COMMUNICATION from the City Plan and Zoning Commission advising that at a public hearing held April 16, 2009, the members voted in support of a motion to **APPROVE** the request from Baker Real Estate, LP (owner) represented by Bernice Baker (partner) for review and approval of "Cold Stream Business Park", a Preliminary Subdivision Plat of property located at 4500 Hubbell Avenue, for creation of nine (9) lots on 49.67 acres of land with extension of a public street from Hubbell Avenue subject to the applicant revising the Plat as follows:

APPROVAL of the proposed preliminary subdivision plat for "Cold Stream Business Park" subject to the applicant revising the Plan as follows:

PRELIMINARY PLAT
COLD STREAM BUSINESS PARK
NE 46TH STREET & HUBBELL AVE

TREE SURVEY
COLD STREAM BUSINESS PARK
NE 46TH STREET & HUBBELL AVE
 4/1/2009 11:20:02 AM CDT
 PROJECT NUMBER: 090019
 SHEET NUMBER: C1.3

PROJECT NUMBER: 090019
SHEET NUMBER: C1.2

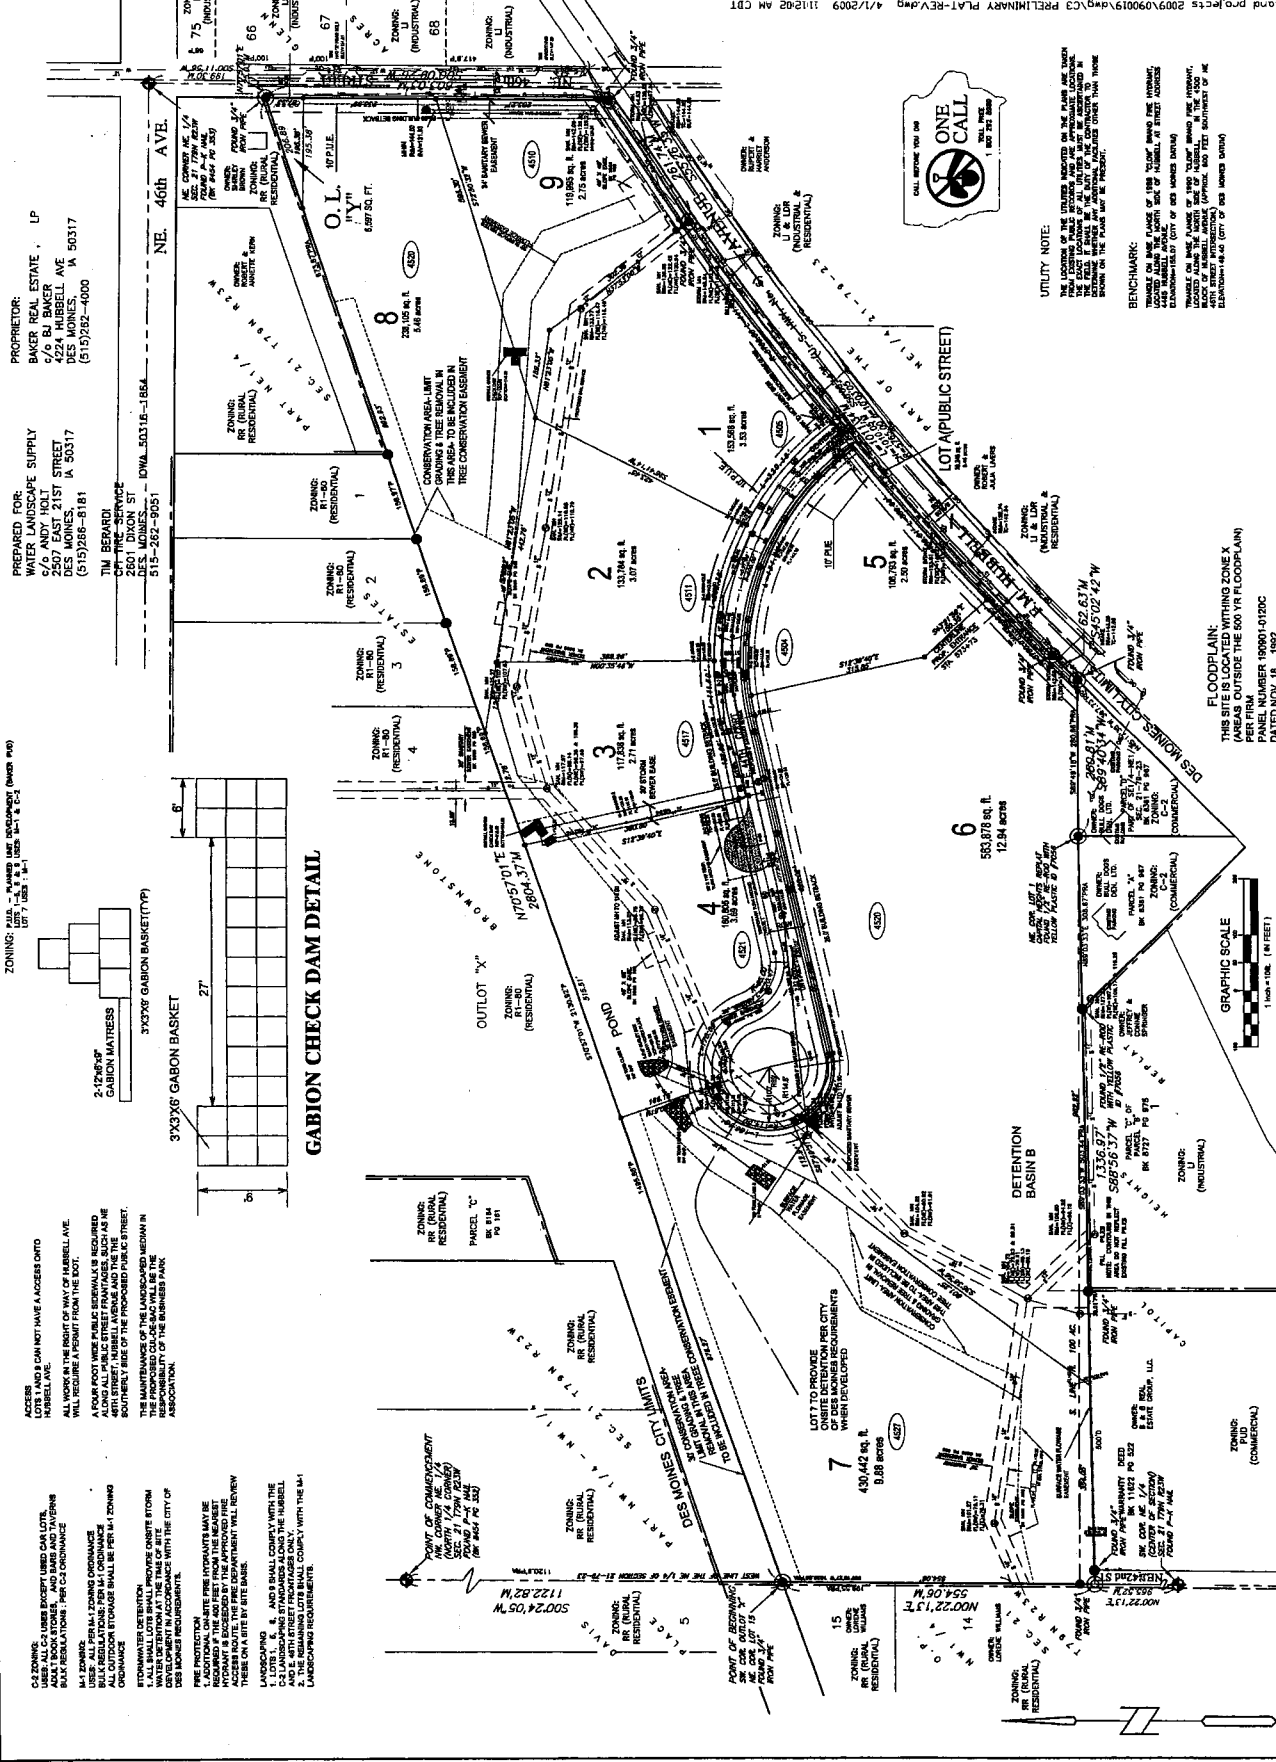
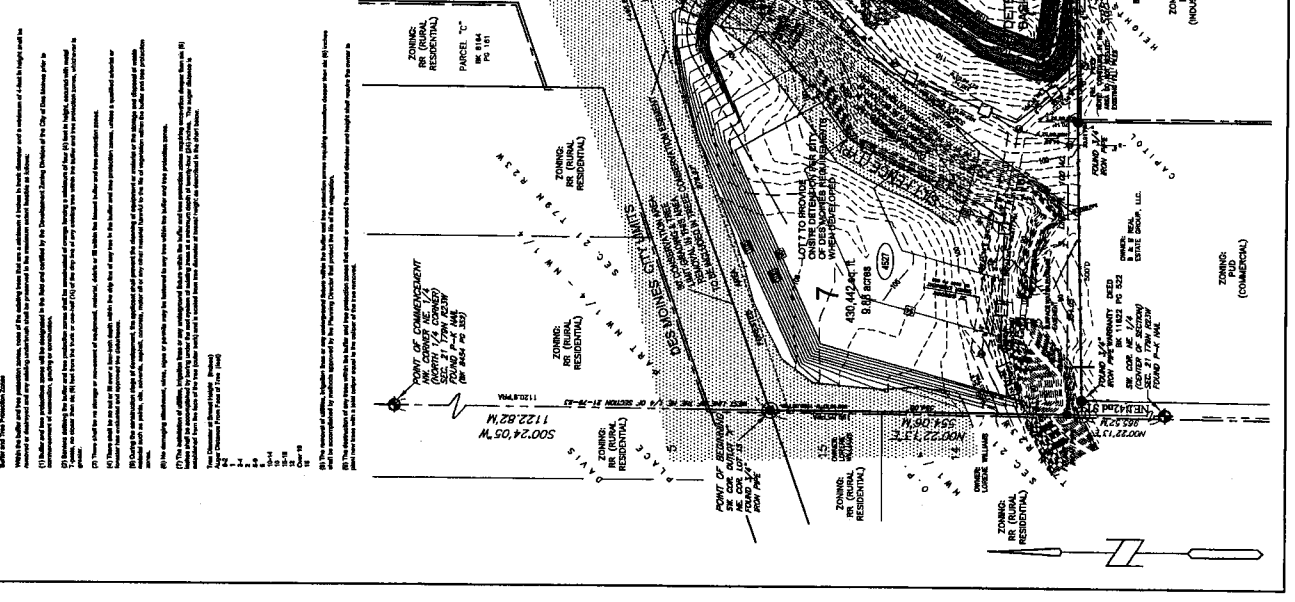
1. Conformance with all administrative review requirements of the preliminary plat by the Permit and Development Center.
2. Provision of a tree mitigation measure note on the preliminary plat that would require five (5) additional 2" caliper overstory tree plantings per lot in addition to any minimum plantings required as part of site plan development.

There are three areas where trees are proposed for removal as part of the pre-development of the preliminary plat: Within the drainage way in Lot 9; the swale area through Lots 3, 4, 5 and 6, and the southern edge of Lot 6. A total of 998 caliper inches of trees of approved species and significant size (6" caliper or larger) are proposed for removal as part of all plat development. Removal of 438 caliper inches are the result of a necessity to make drainage improvements protecting the sensitive steep slopes of the drainage area running along the northern and western edges of the plat. Staff does not recommend that the developer be required to mitigate these trees. This leaves a remaining 560 caliper inches trees to be removed.

The minimum open space and street trees required by the PUD conceptual Plan requirements will mitigate a minimum of 260 caliper inches of trees. This narrows the total unmitigated removals to 300 caliper inches of trees. However, this does not account for additional landscaping that will be required as part of off-street parking requirements within each lot development. Staff estimates that approximately five (5) 2" caliper trees will be necessary per lot for a total of 45 trees (90 caliper inches) to mitigate trees that will not be replaced by additional required landscaping at the time of development. Staff recommends that provision of these trees be made a condition of any preliminary plat approval.

Erik Lundy presented staff report and recommendation. Corrected the written report by stating that Des Moines Waterworks will allow a connection to the feeder main in Hubbell at the point where the proposed street intersects, rather than extending an existing main in NE 46th Street.

Bruce Heilman asked will any of the tree loss because of the erosion situation be on the north lot line.

Bruce Heilman asked will this erosion control project extend across that north boundary.

Erik Lundy stated yes, the area that is being reworked to alleviate the slopes, the check dams are provided where the trees will be removed.

Erik Lundy stated that it did not appear to in the drawings, but if they need to encroach they would have to secure easements for construction from those owners.

Chuck Bishop, Bishop Engineering, 3501 104th Street stated they do have a conservation easement along the north lot line adjacent to the residential lots. The only place that there is not a conservation easement is the area along Lot 4 because we are actually making this location a wet pond to try to hold back the water and release it again through the creek to the southwest.

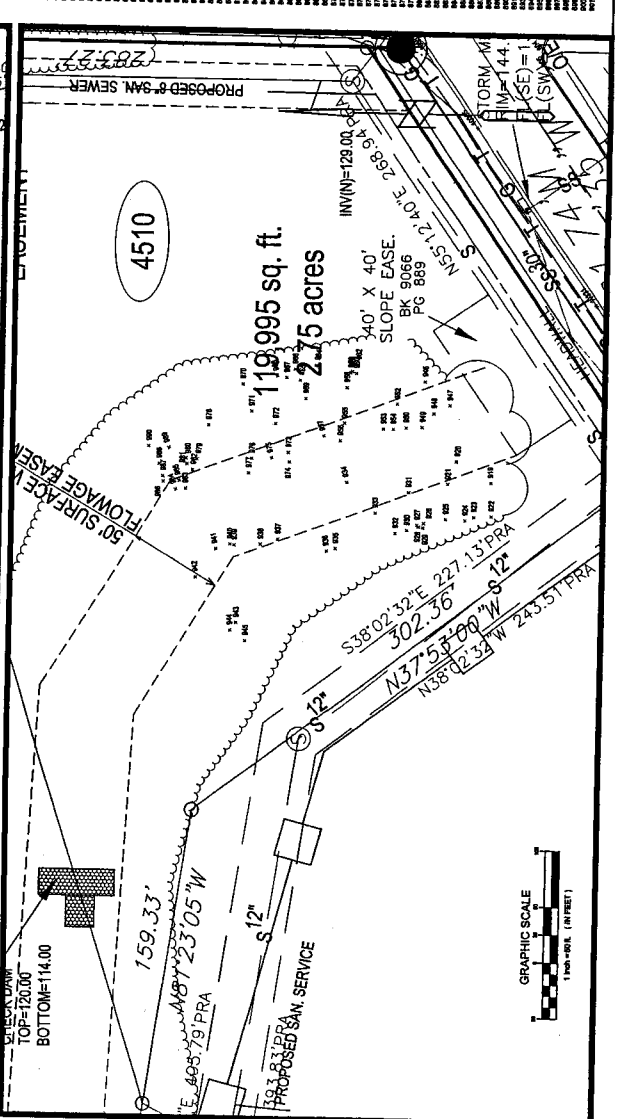
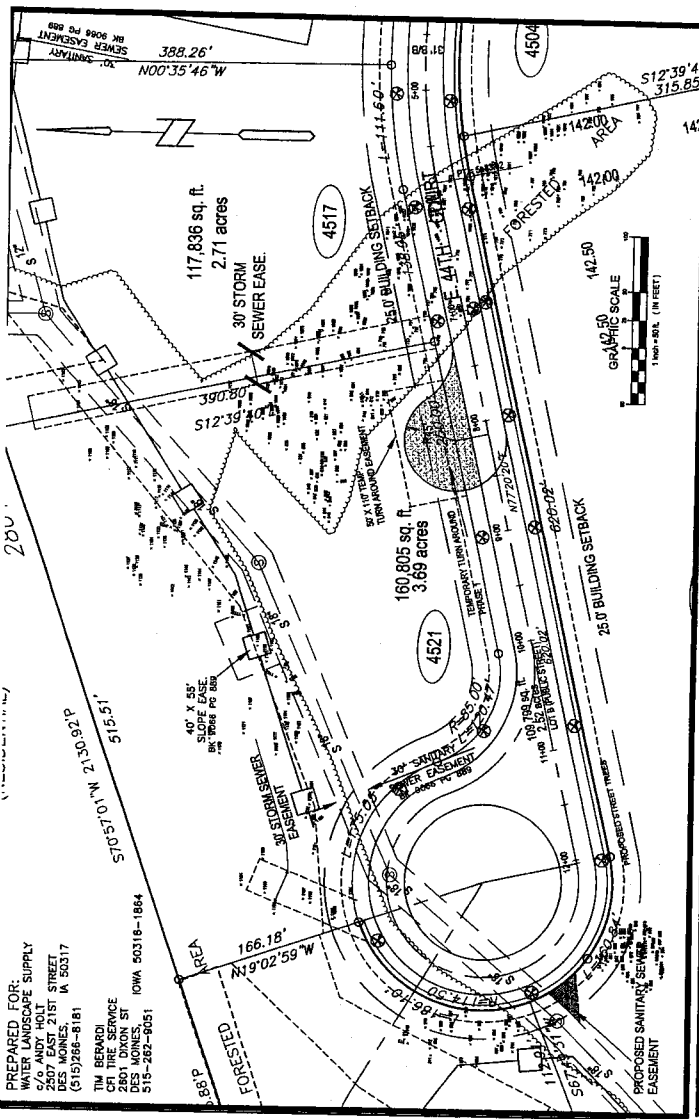
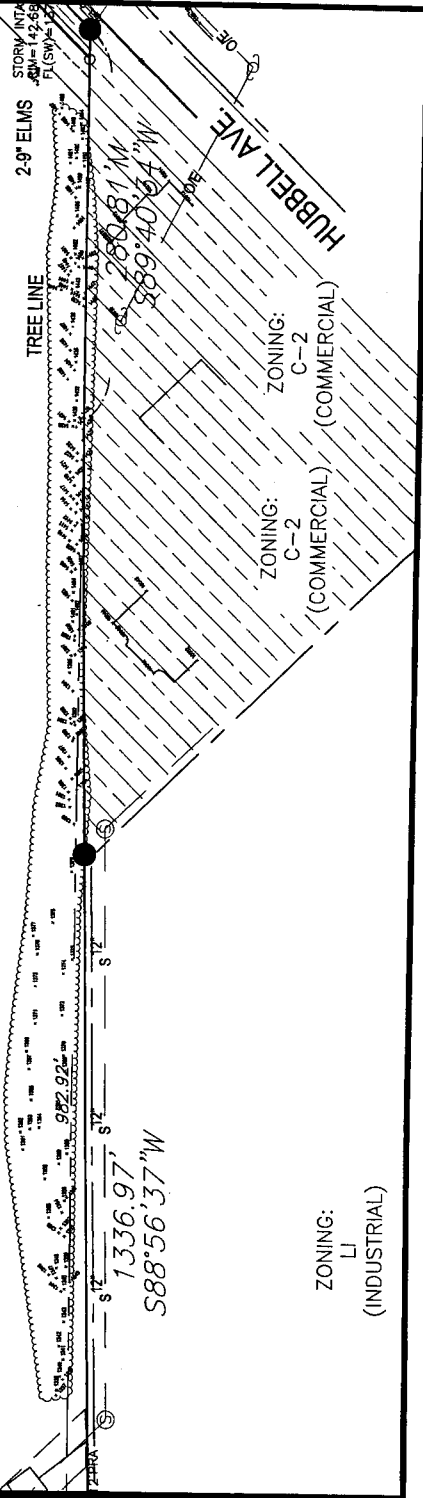
The recent PUD Conceptual Plan amendment requires that tree protection measures shall be included on any site Development Plan or Preliminary Plat to provide detail for trees identified for protection. Also, a mitigation plan shall be approved for all identified trees for removal as part of any site Development Plan or Preliminary Plat. The applicant provided a tree survey with the preliminary plat submittal.
